LSD Ebersole Center Food Service

Bid Pack 2, Addendum No. 1

Narrative of Changes

Project Name:	Ebersole Center Food Service – Equipment Replacement & Renovations SO-1853	Date:	April 3, 2026
Project Location:	3400 2 nd St Wayland, MI 49348	Architect's Project #:	26000750A
Owner/Client:	Lansing School District	Attention:	David Beckering
Issued to:	Beckering Construction	Email:	djb@beckering.com
City/State:	Grand Rapids, MI	Zip:	49548

DRAWING NUMBER:
EL101

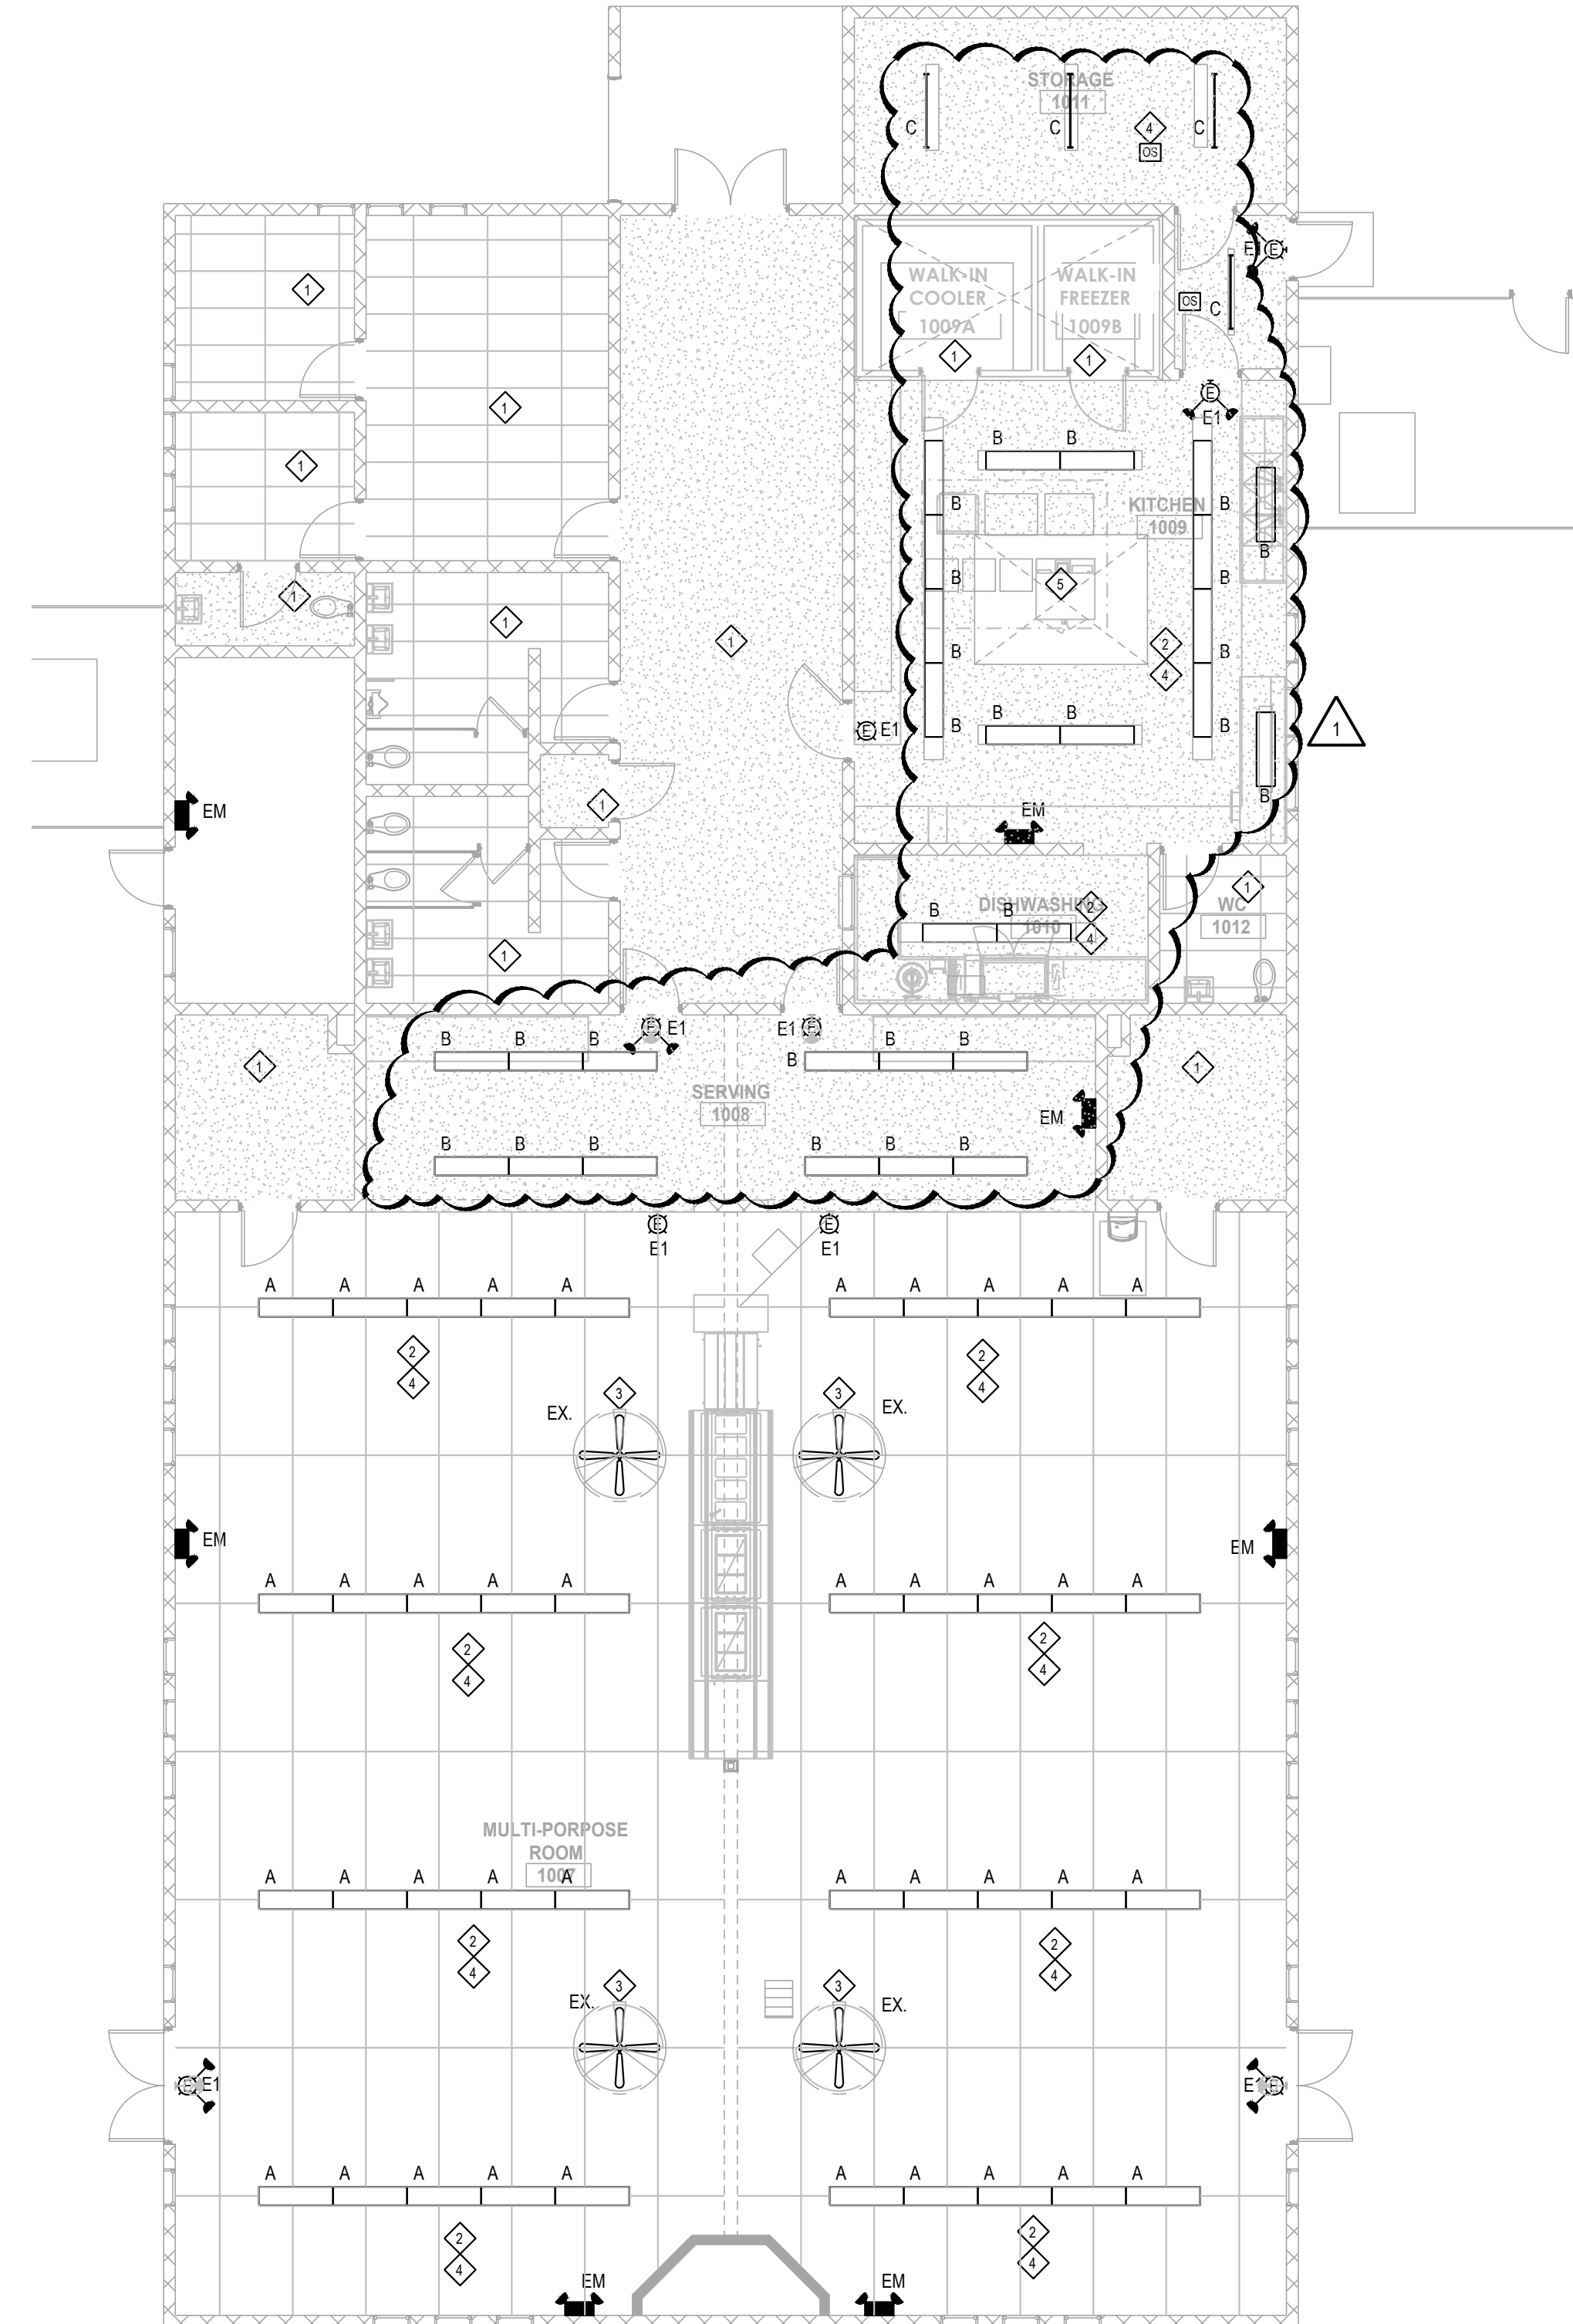
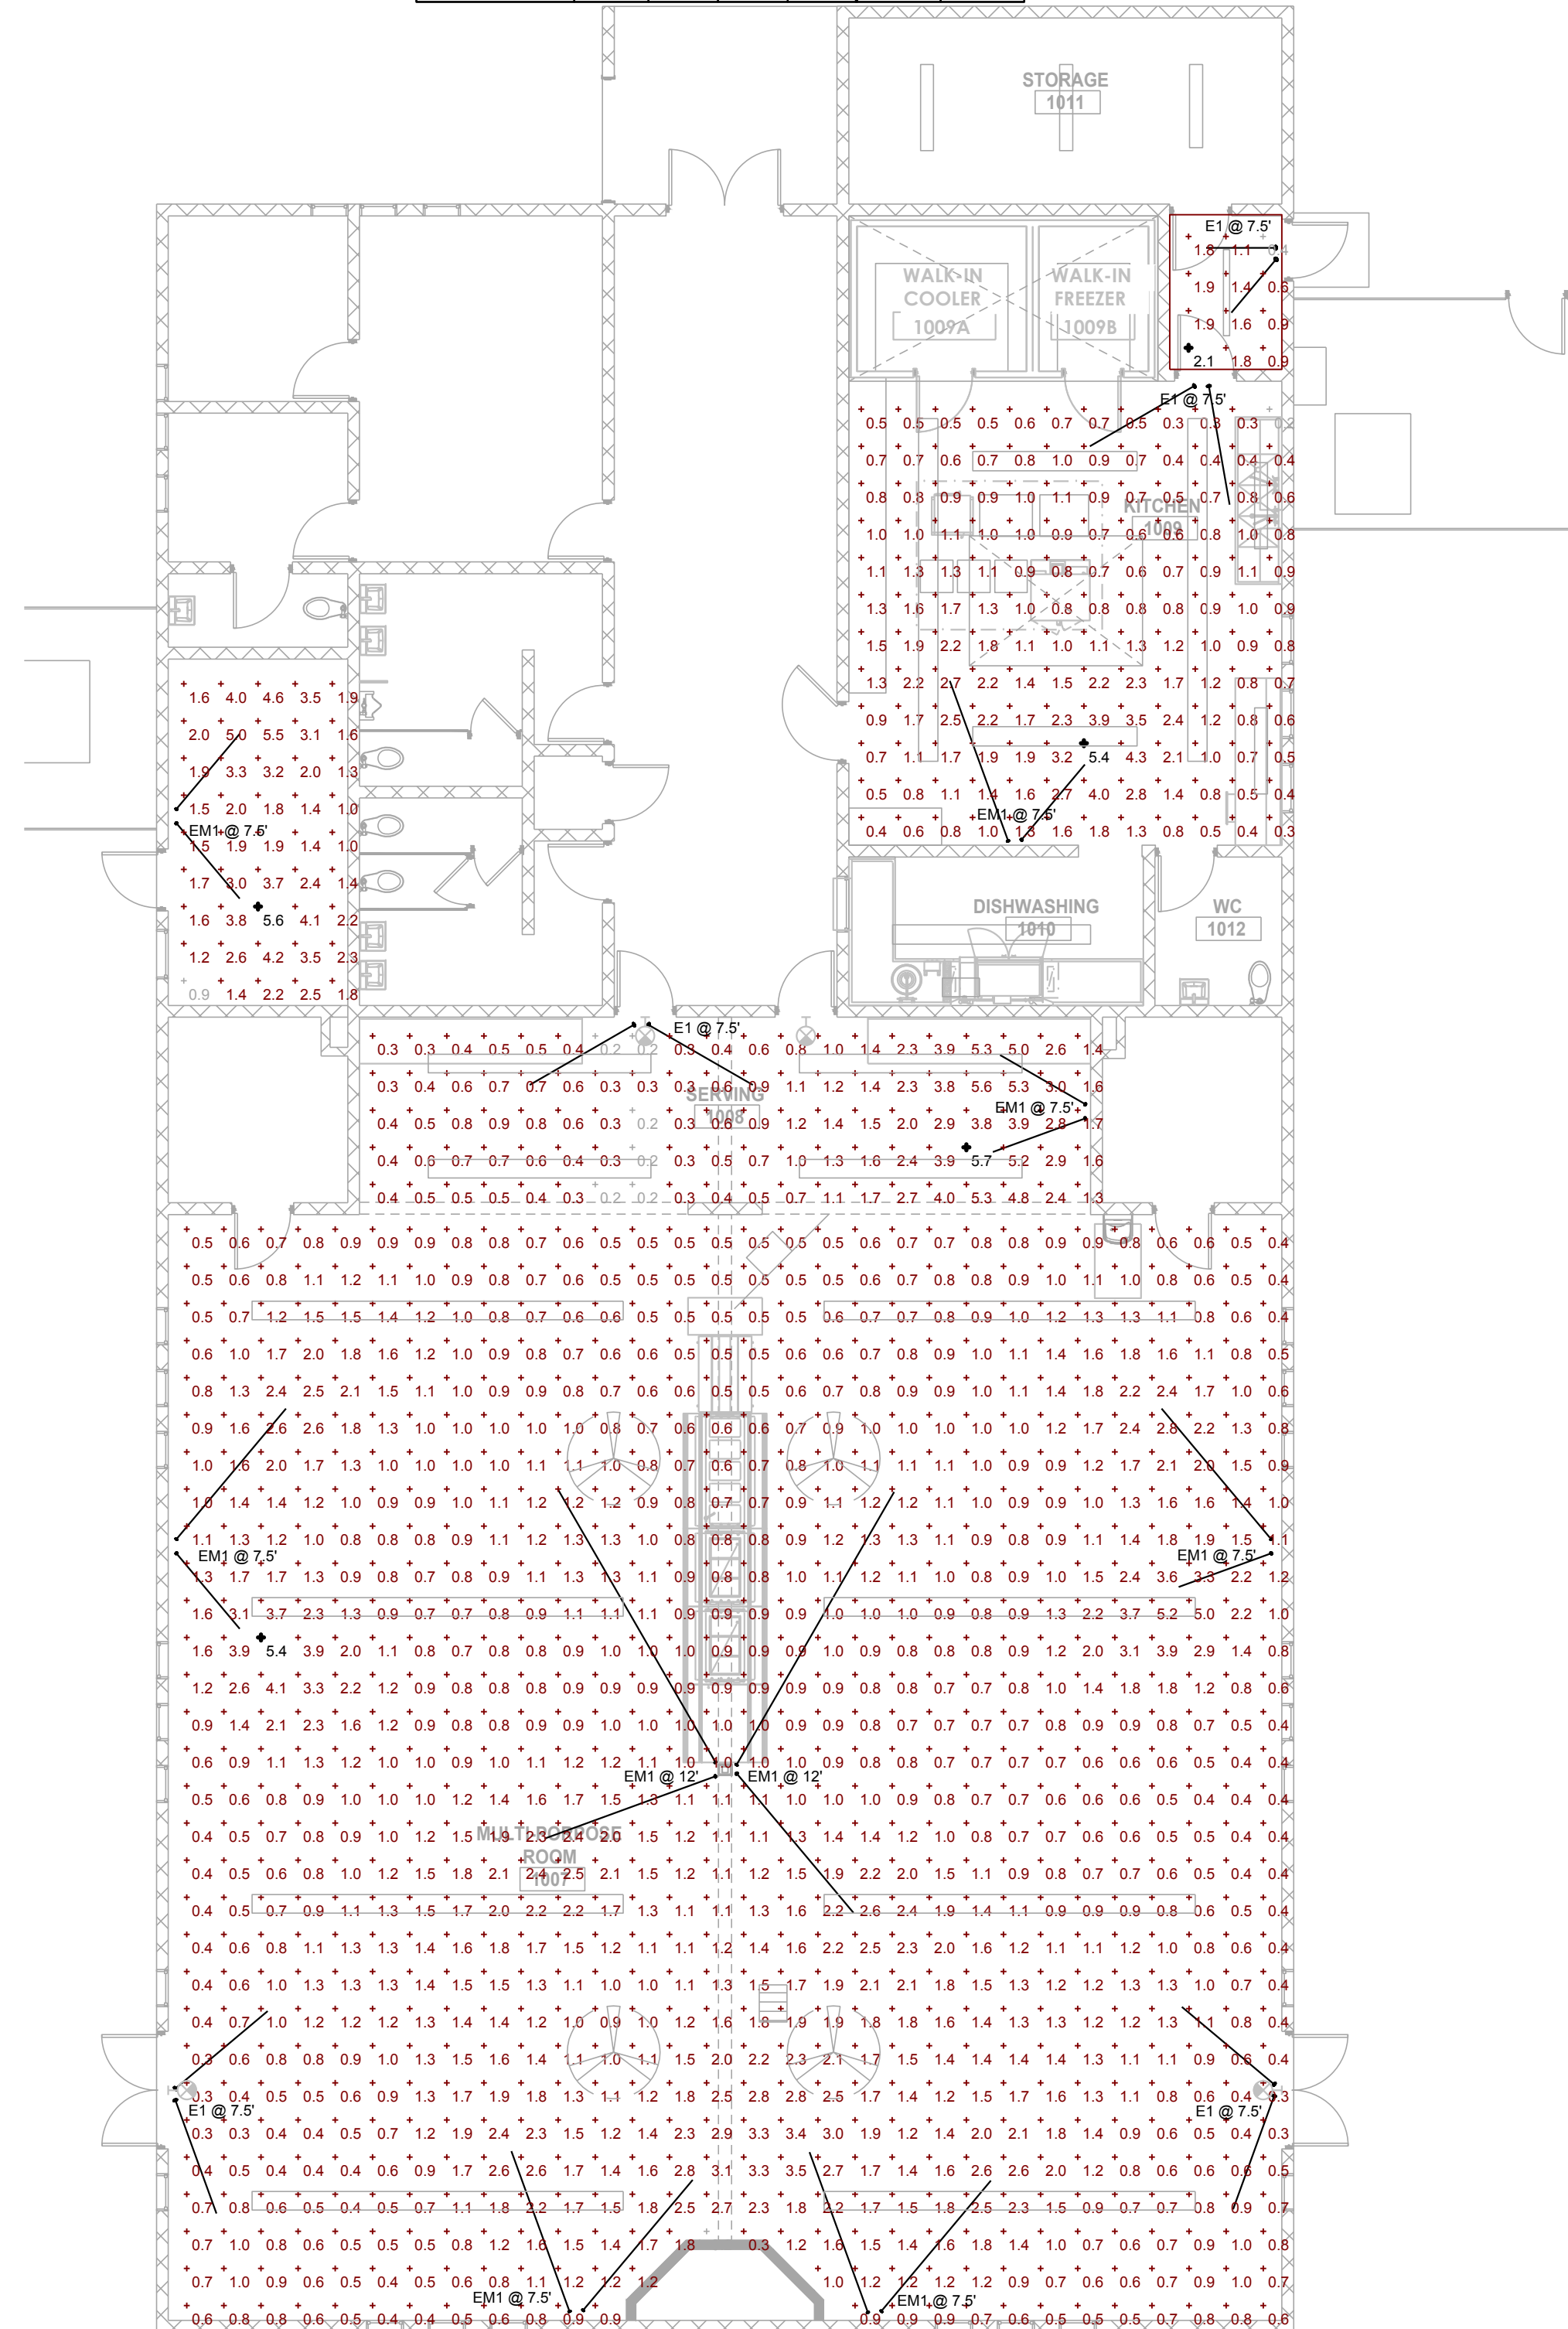
- EL101 – FIRST FLOOR PLAN – LIGHTING / PHOTOMETRICS (Reissued)
 - Changed fixtures in kitchen and serving 108 to type B

DRAWING NUMBER:
EP101

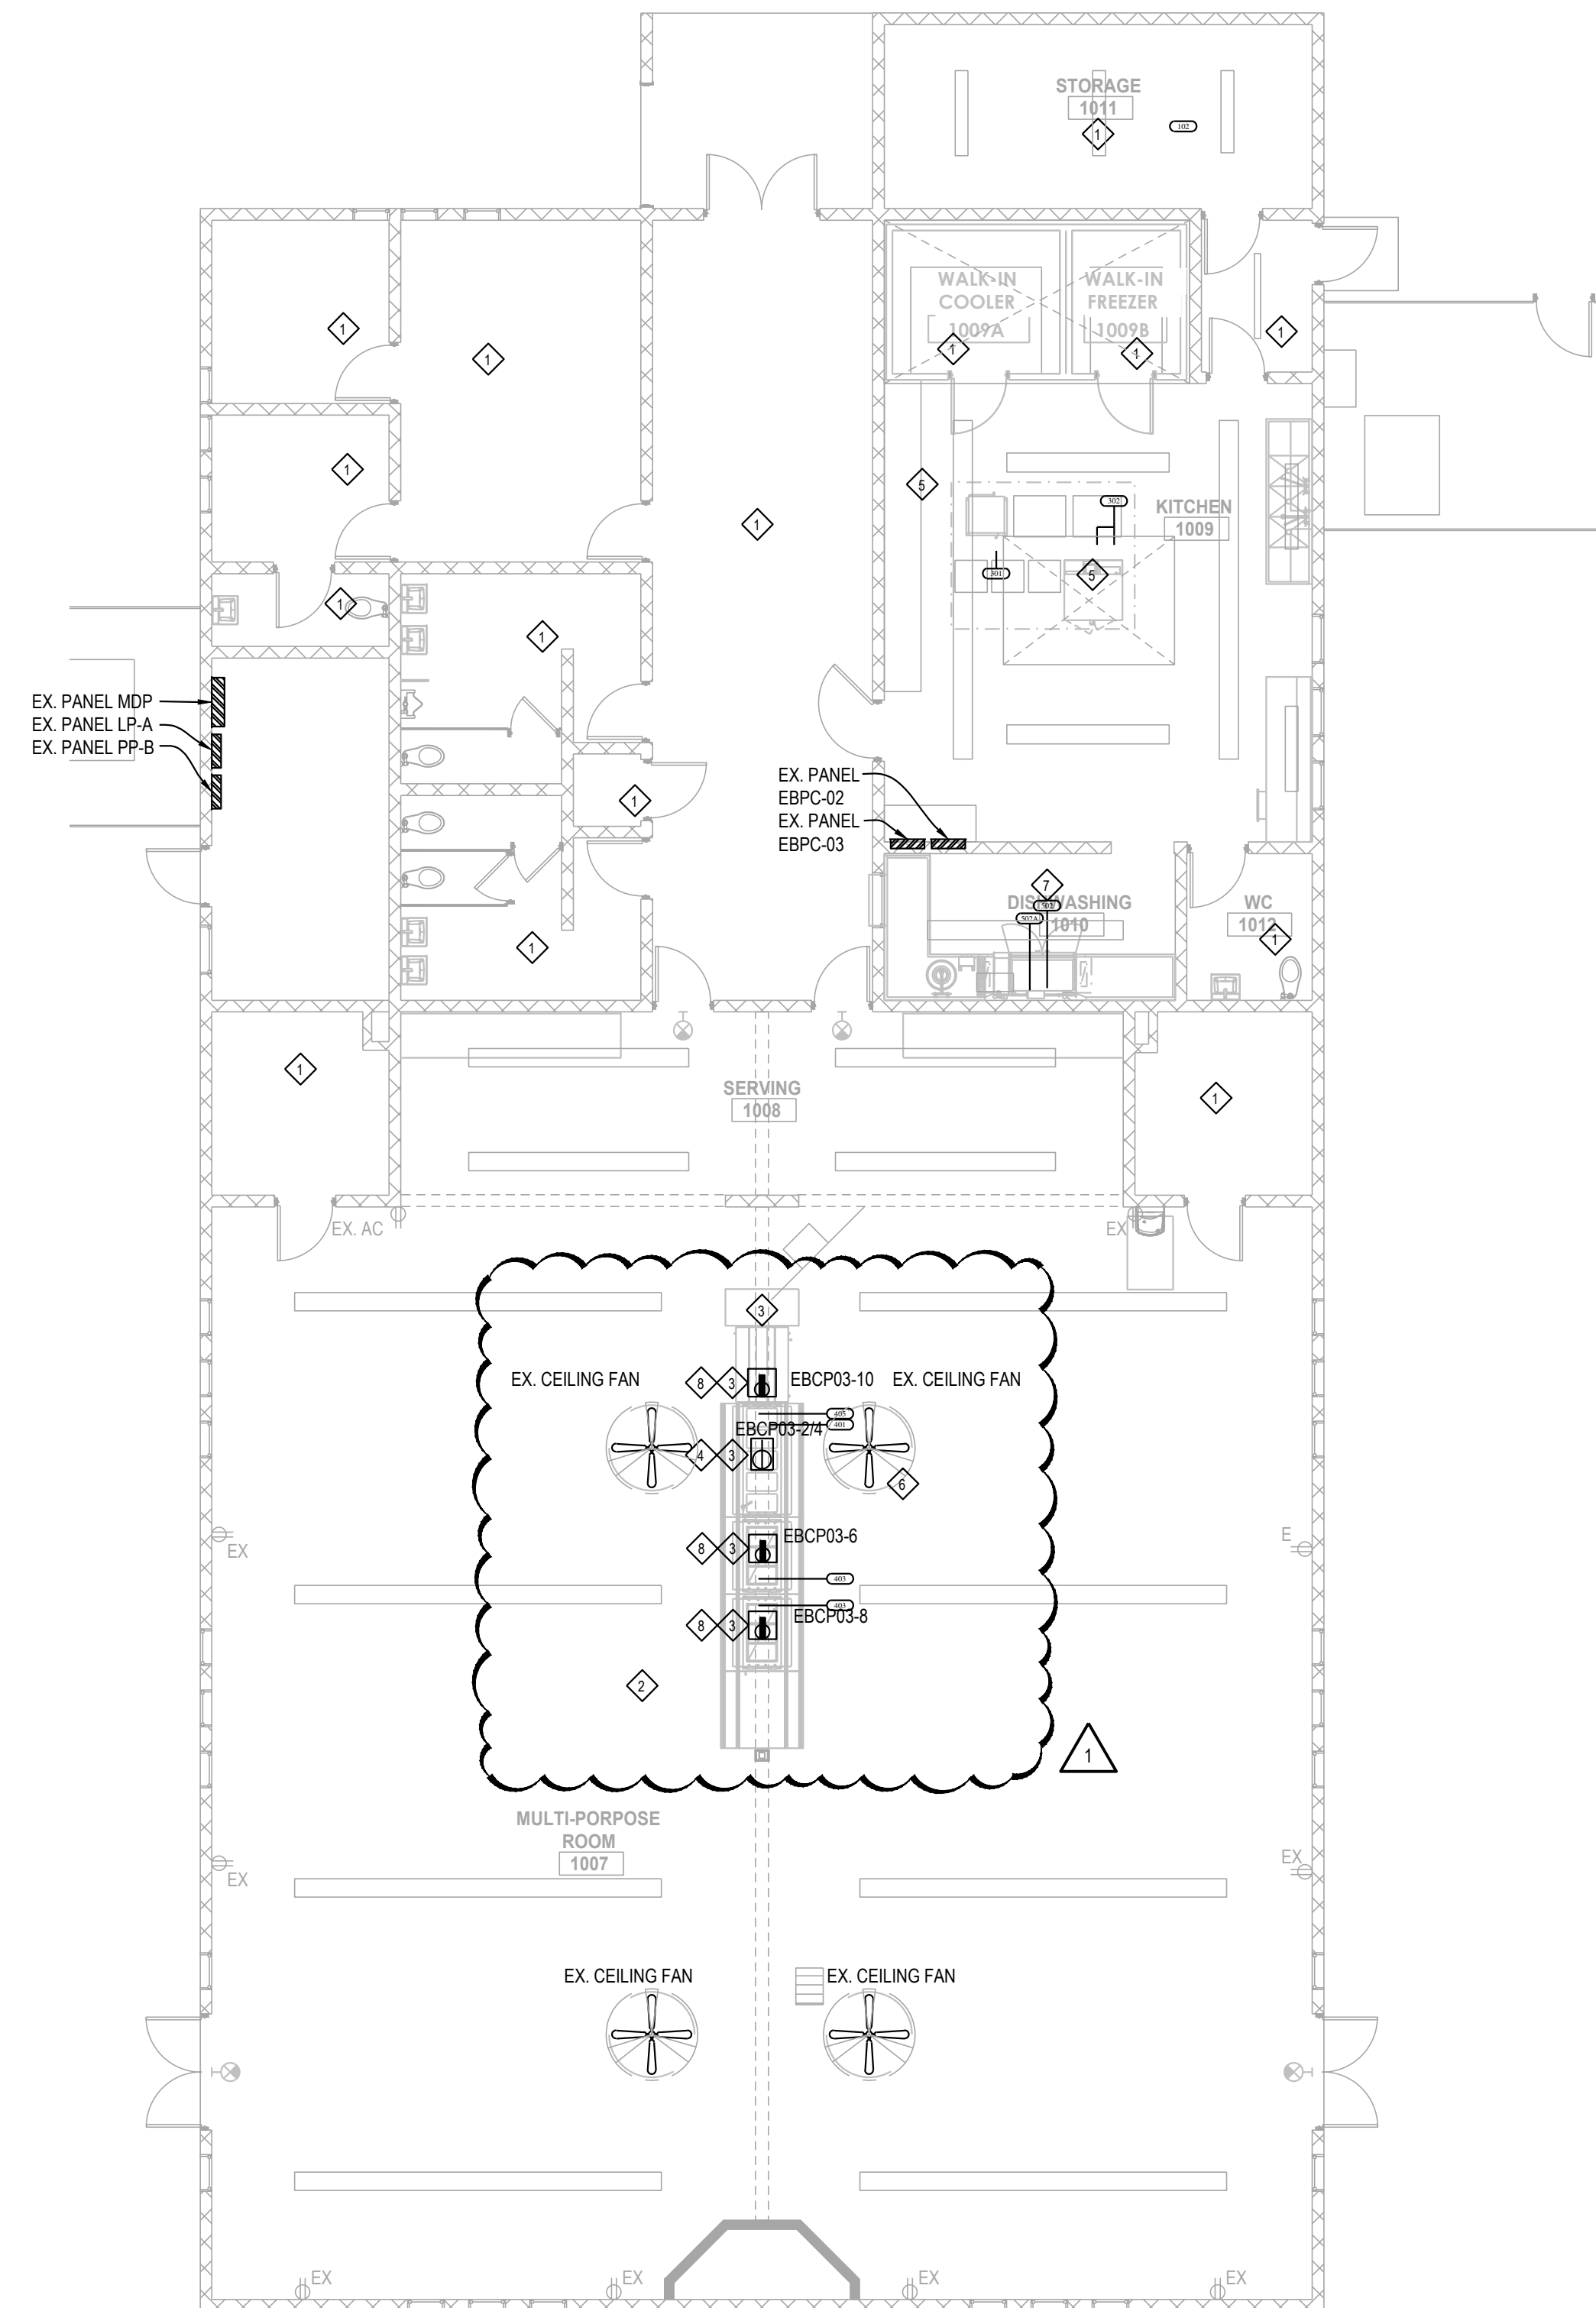
- EP101 – FIRST FLOOR PLAN – POWER (Reissued)
 - Changed keyed note 3 to utilize the column for conduit drops to serving line and provide a rubber ramp to cover surface mounted conduits along the floor.
 - Revised device layout and notations at the serving line.
